Re: Carter Becker, Shore Drive (Map 5, Lot 96A)
Coastal Waters Commission- Response to Comments at 9/13/23 Meeting

On behalf of my client Carter Becker, I provide the following additional information as requested by the Commission, along with responses to various comments made during the Commission's hearing on September 13th.

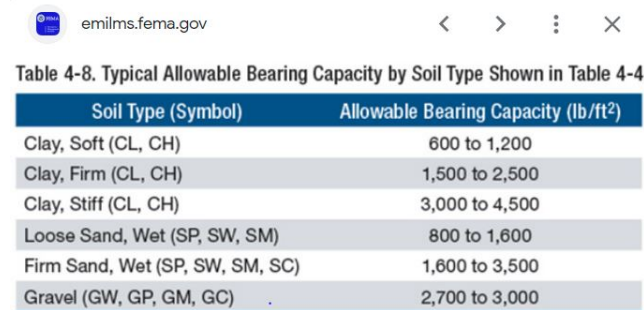
The picture below shows the dollies; the mat arrangement is not for the proposed launch ramp. There will be four axles (one dolly) riding on one section of mats that is 16 x 20 feet area. That is (4) 4 x 16 runners laying perpendicular (gap for skag) on top of (5) 4 x 20 mats = 320 SF.

The total loading on the aforementioned 320 SF of mud flat is: 9 mats that weigh ~#2,000 lbs. each (5 -4' x 20' mats w/ 4 - 4' x 16' mats on top) totaling #18,000, two power dollies (w/ 16 tires total) weighing #11,600 (each dolly #5,300, and one half the vessel weight at #90,000 equals a gross total of #119,600.

The gross weight of 119,600 lbs. divided by the 320 SF contact area **equals approximately 375 lbs per SF.** This is nearly a 2.0 factor of safety when compared to the allowable of 600 lbs. / SF shown in the Soils Bearing Capacity chart found at the beginning of this letter.
